## **PROCESS CHANGE NOTIFICATION PCN0603**

### **Cyclone II Family M4K Memory Block Modification**

**Figure 1: Cyclone II Device Revision Number Identification**

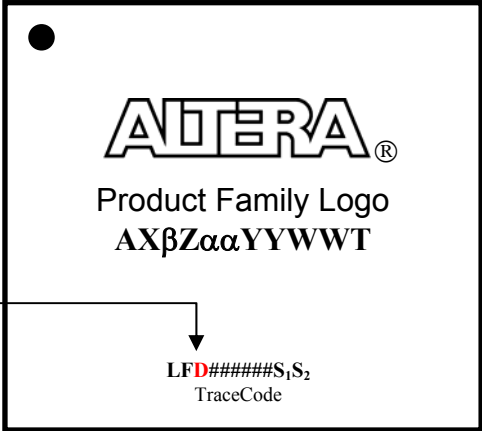
Production Cyclone II devices with the M4K memory block modification will start shipping in the second quarter of 2006. The modified devices can be identified by the revision number, as indicated in Figure 1.

Device	Modified Revision
EP2C5	B
EP2C8	B
EP2C20	B
EP2C35	C
EP2C50	B
EP2C70	B

**D** in position 3 of the lot number indicates revision
